DEP File No. 0530021-008-AC (PSD-FL-227B)  
Florida Crushed Stone Kiln 2  
Hernando County

**NOTICE OF PERMIT DENIAL**

**RESPONSES TO FDEP QUESTIONS AND  
REQUESTS FOR ADDITIONAL INFORMATION  
PREPARED BY RTP ENVIRONMENTAL ASSOCIATES, INC.®**

**MECHANICAL PROCESS FLOW SHEET  
PREHEATER, KILN & COOLER SYSTEM**

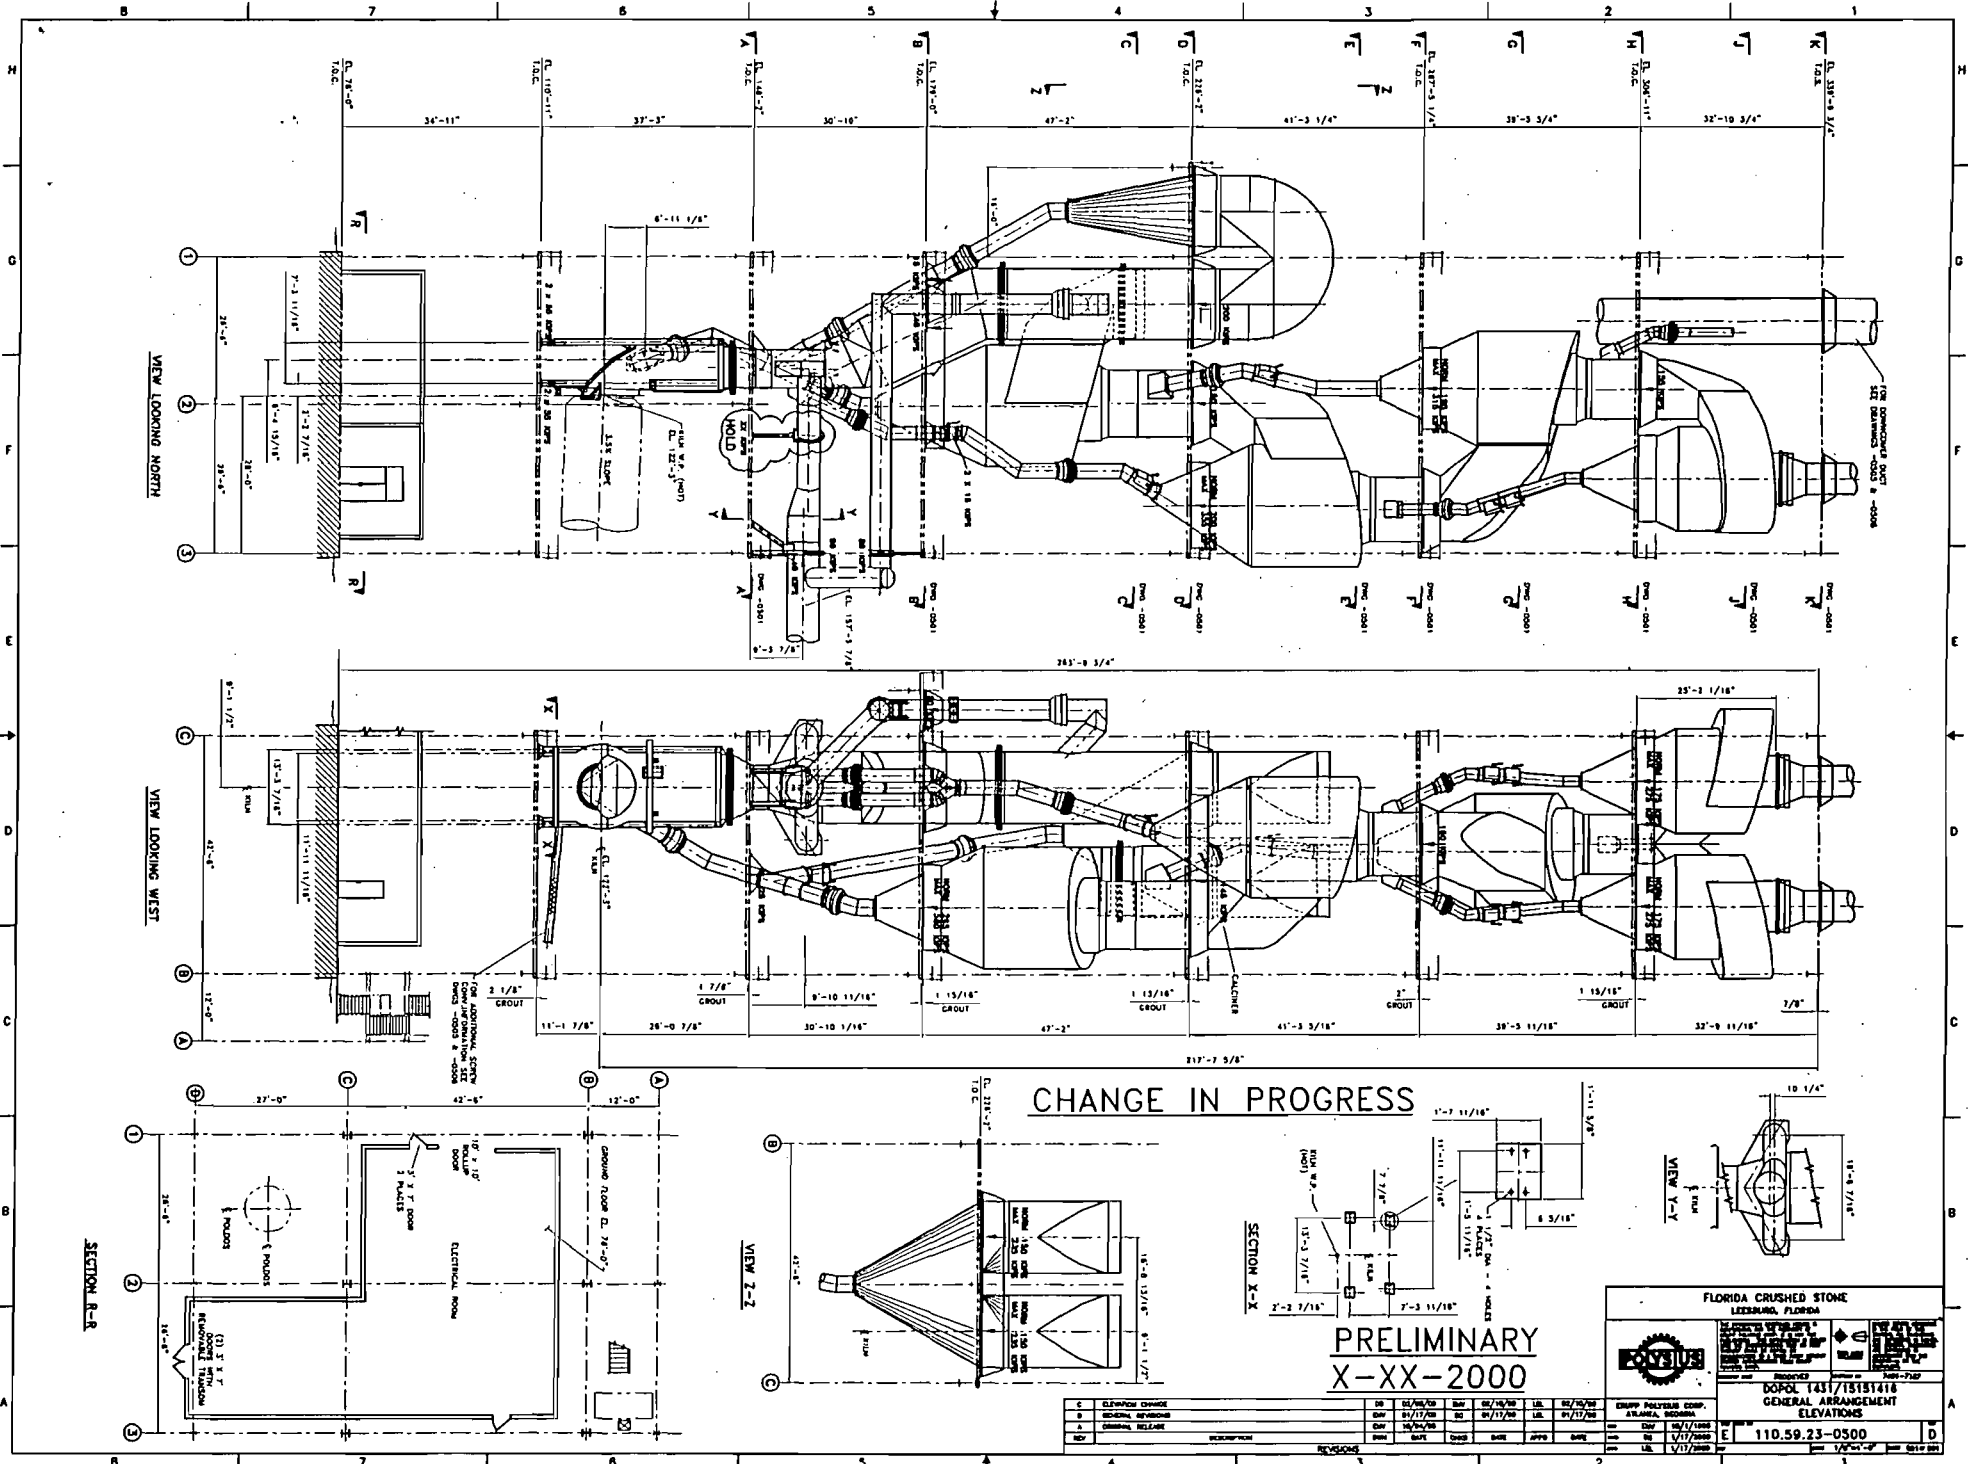
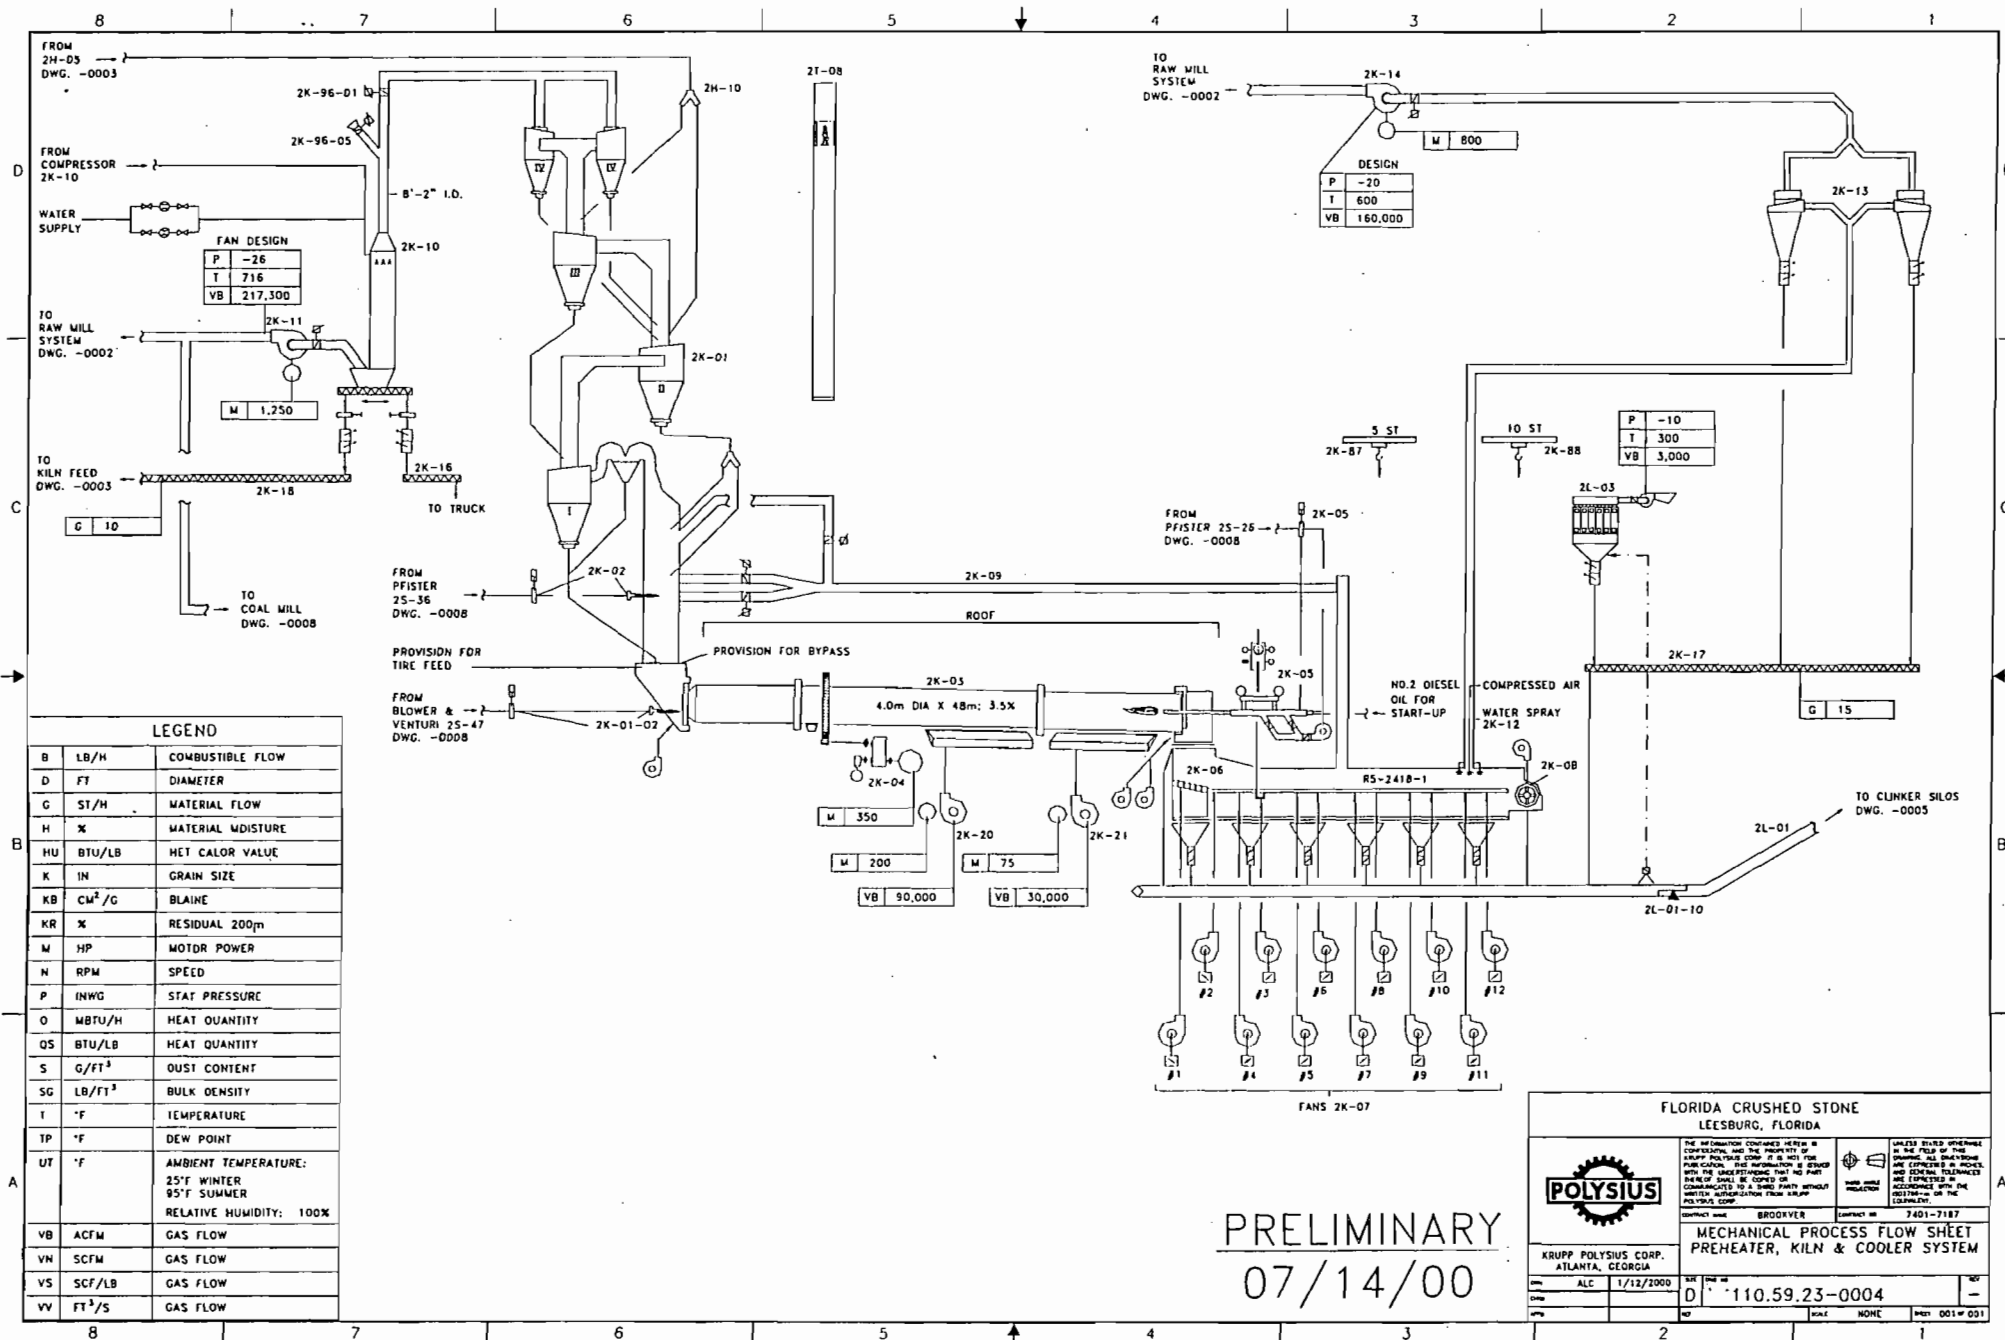
The Department requested updated drawings and design details. However, the drawings submitted (marked "Change in Progress" and "Preliminary X-XX-2000") do not indicate a finalized design. For example, the drawings do not show the bypass referred to in Rinker's BACT update and May 8 response which states: "Rinker is proposing installation of a bypass at the same time of construction as the new kiln." According to the time line provided in the submittal, a construction contract is scheduled for signing in July 2002. This is more than seven years since receipt of the first application submitted by the previous owner. It should be possible to provide a more recent and complete set of drawings (suitable for our purposes) showing the proposed final design.

4. Calciner Details and Options. Describe the calciner, its burners and the features incorporated to minimize  $\text{NO}_x$  formation.

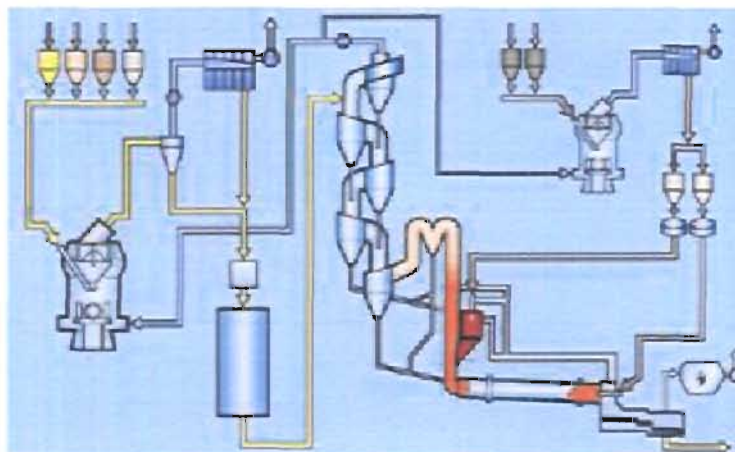
Initially describe the version that does not operate in staged combustion mode such as provided in the 1996 design. This is the baseline from which further  $\text{NO}_x$  reductions and costs should be calculated. Polysius has disseminated quite a bit of information about its basic calciners. Such a calciner was installed at Florida Rock and is known as the PREPOL Calciner.

Then describe the staged combustion version of the calciner. Presumably this is the level of control planned by Rinker based on information in the BACT update. The Polysius version is known as the PREPOL MSC Calciner. A version of this calciner was specified for Suwannee-American Cement.

Recently, the PREPOL Calciner at Florida Rock was converted to a PREPOL MSC Calciner in order to control  $\text{NO}_x$  and facilitate tire burning. Polysius would be very aware of the costs of incorporating this feature during initial construction or as a retrofit. Estimate net costs to accomplish this  $\text{NO}_x$  reduction by staged combustion and include any savings from the added ability to burn tires.

The Department's request to "describe the version that does not operate in staged combustion mode such as provided in the 1996 design" as well as "starting with the same basic configuration, estimate the NOx reduction by SNCR alone" is not possible. As noted in the Department's first comment, the calciner design not incorporating MSC is "obviously out of date." However, a preheater-precaciner kiln contains a calciner vessel for the basic function of calcining the preheated raw meal prior to entrance into the kiln. The advancement of the MSC calciner does not change the function of the calciner, it merely modifies the supply points of secondary and tertiary air to create "reducing" zones and "oxidizing" zones in an attempt to reduce emissions of NOx and CO. The basic components of the calciner remain unchanged. Furthermore, the FCS Kiln II permit has specified a NOx emission limit of 2.8 lbs NOx per ton clinker with and without MSC. Thus, no incremental difference in cost could be derived. The ability to utilize MSC within the calciner will assist Rinker in providing "reasonable assurance" of achieving permitted emission levels. However, no significant design or component changes will be involved relative to the calcining vessel.

The following description, provided by Poysius, focuses on the calciner system that will be constructed for the FCS Kiln II. Subsequent costs for added control will be estimated in the response to question 7 (Cost Estimate for NOx Control by SNCR).

The calciner design for the FCS Kiln II plant will be similar to that provided to, and later modified at Florida Rock's plant near Gainesville incorporating the latest PREPOL MSC technology. The diagram shown on page 2 of the Department's February 28, 2002 letter indicates a combustion chamber mounted alongside the calciner. This design concept is being considered as a possible approach for the FCS plant as well. This design is called the PREPOL MSC-CC by Polysius.
